Comment # and Topic	Comment	Response																		
1 – Delineation	<p>Please provide a map showing all of the sample points taken for the wetlands delineation, including the paired sample points taken on either side of the delineated boundaries. Please include an explanation of the surface features used to draw the boundaries and any other technical work that was performed for this delineation.</p>	<p>Please see the enclosed <i>Updated Jurisdictional Delineation Report</i> for all observation locations within the coastal zone.</p> <p>The limits of the jurisdictional areas depicted in the enclosed <i>Updated Jurisdictional Delineation Report</i> are based upon the vegetation boundaries visible on aerial photography and confirmed in some locations using GPS based on the presence of hydrophytic plant communities. Soil pit data was not collected at this time as a result of restrictions on sampling on the Marine Corps property.</p>

Attachments

I-5 WIDENING ALTERNATIVE AT SAN MATEO CREEK

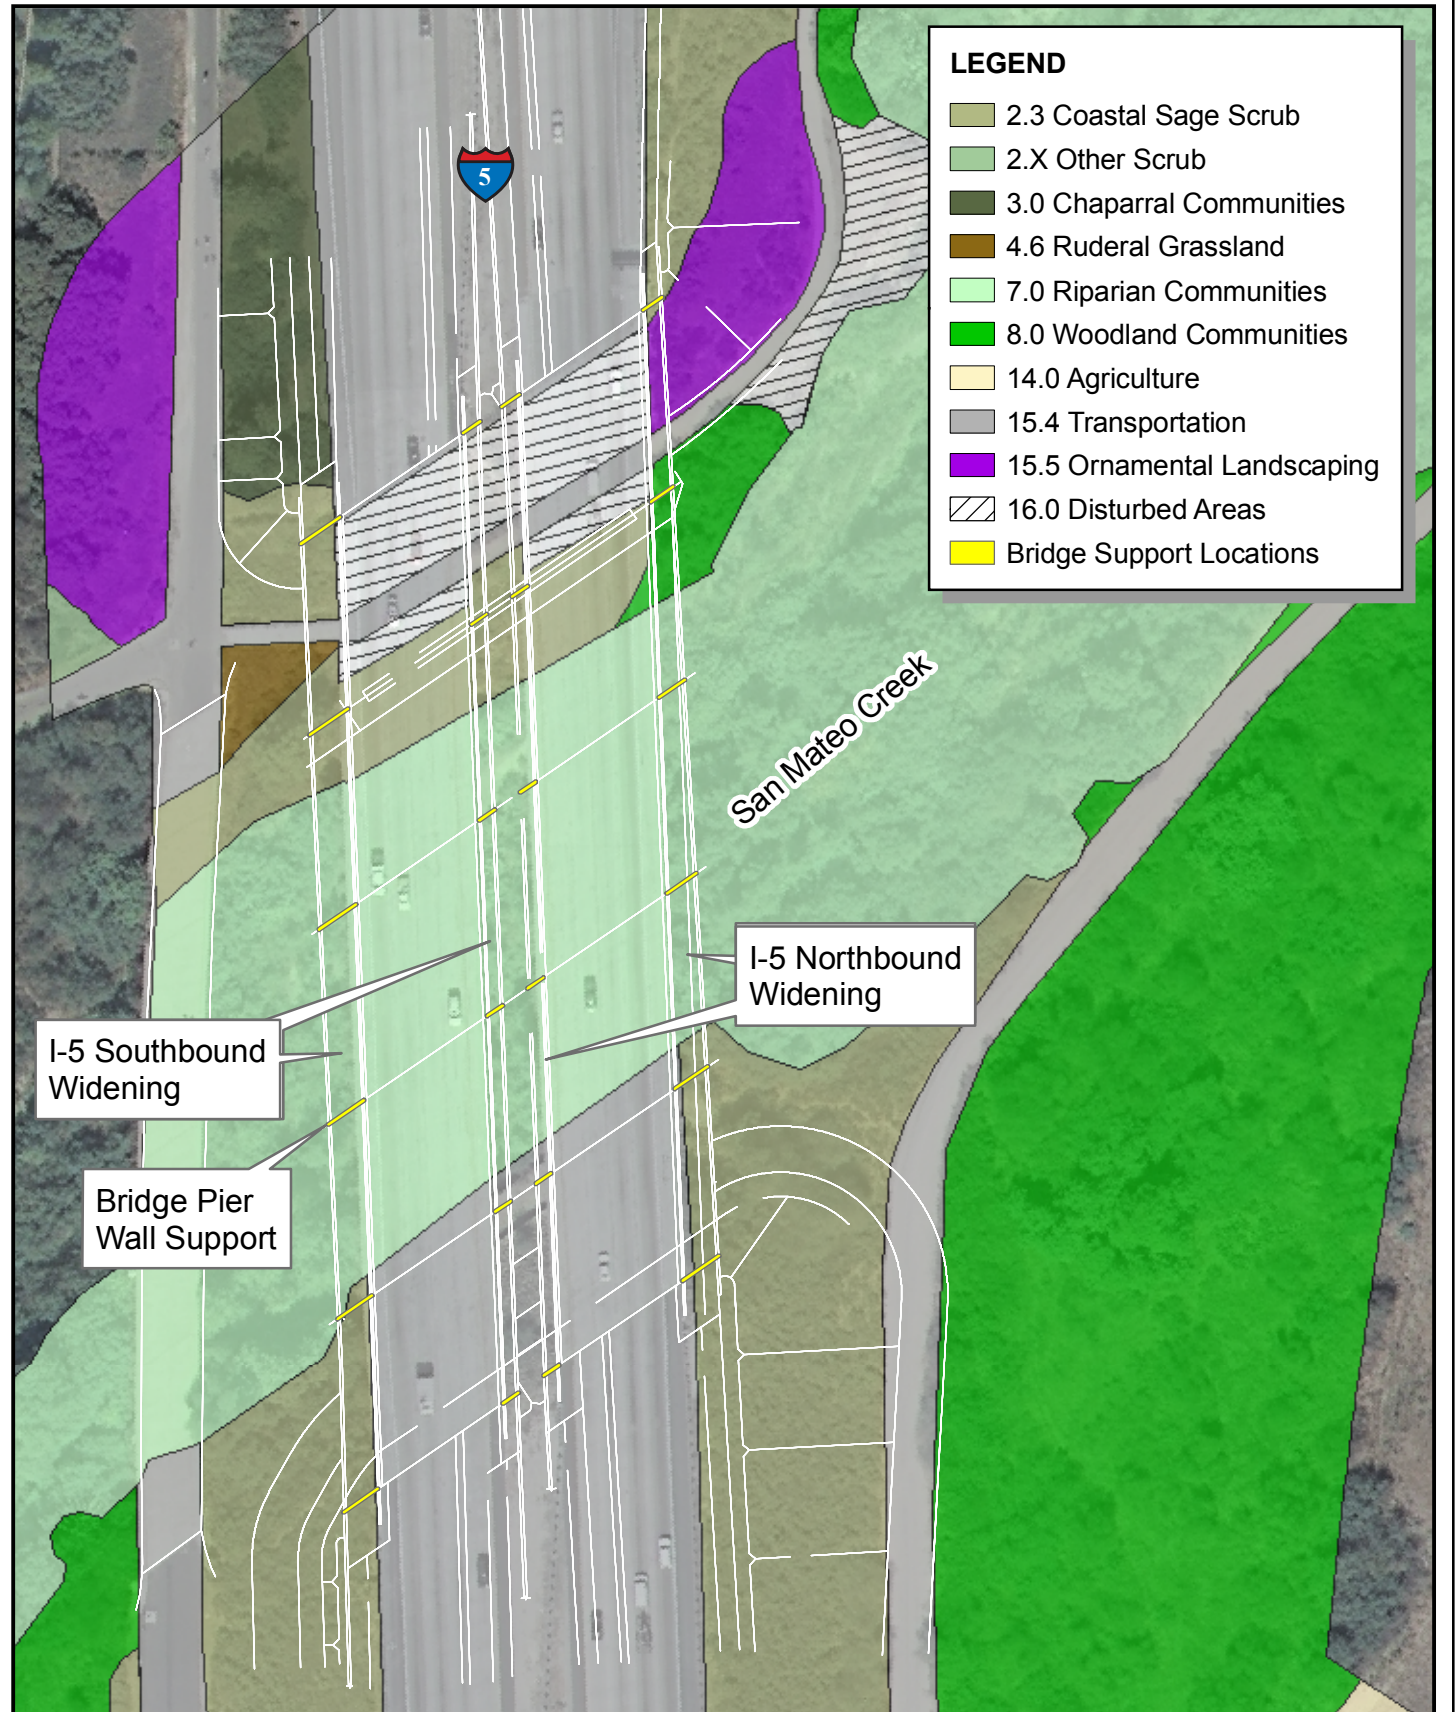
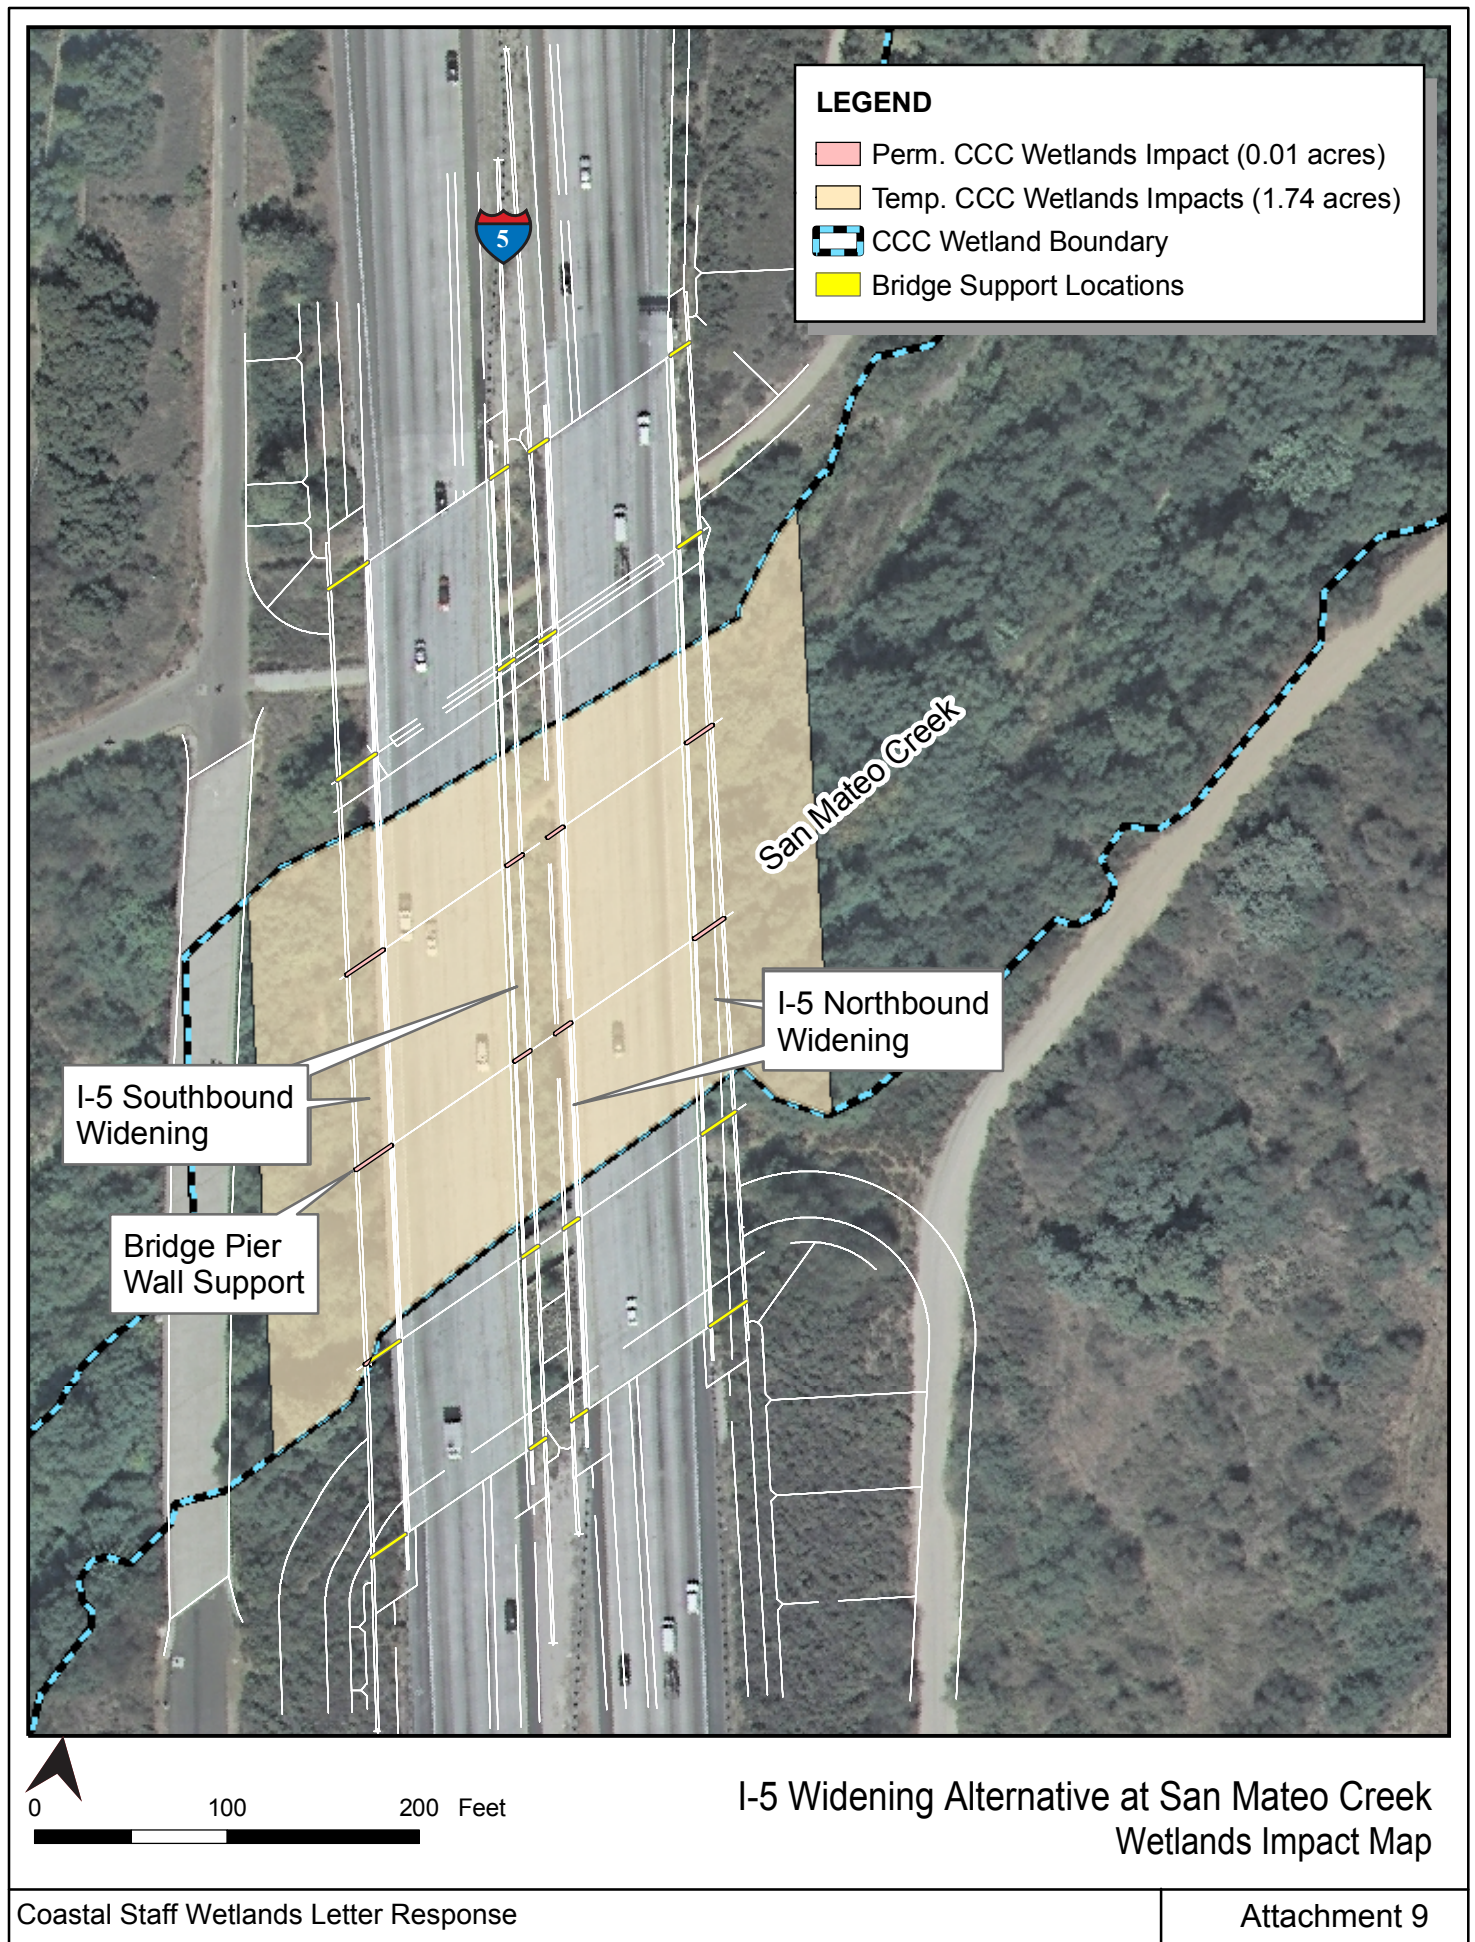
24 – I-5 Widening	<p>Please provide a map that shows what type of construction is proposed at San Mateo Creek for the I-5 Widening Alternative, the vegetation mapped* in and around the creek, the wetland delineations, and the permanent and temporary impacts to wetlands. Please explain why these impacts would be significant and permanent, while the FTC-</p>	<p>Please see <i>Attachment 9: I-5 Widening Alternative at San Mateo Creek</i> for maps depicting the location of temporary and permanent wetlands impacts, and vegetation types, at San Mateo Creek associated with the I-5 Widening Alternative.</p> <p>To clarify, impacts to wetland resources at San Mateo Creek for the I-5 widening would be similar to those of FTC-S, as both would require permanent wetland impacts. As shown in <i>Attachment 9</i>, a total of 8 pier wall extensions would occur completely within the delineated wetlands and one additional pier wall extension would occur partially within the delineated wetlands.</p>

Comment # and Topic	Comment	Response
	<p>S would not have significant adverse impacts (p. 50-51).</p> <p>*Please use a standardized vegetation classification system.</p>	<p>As stated on page 51 of the Consistency Analysis, in addition to wetlands impacts at San Mateo Creek, construction of the I-5 widening alternative consistent with Caltrans standards would result in the displacement of 838 existing homes and 382 existing businesses, including those in coastal communities, such as San Clemente.</p> <p>For more information on the I-5 widening alternative, please refer to the report entitled <i>Alternatives Analysis Summary for Foothill Transportation Corridor – South (FTC-S)</i> submitted to Coastal Staff on February 28, 2007. Appendix A of the <i>Alternatives Analysis Summary</i> includes a detailed description of the I-5 widening alternative development methodology as well as a series of figures depicting the alternative's impacts to homes and businesses.</p>
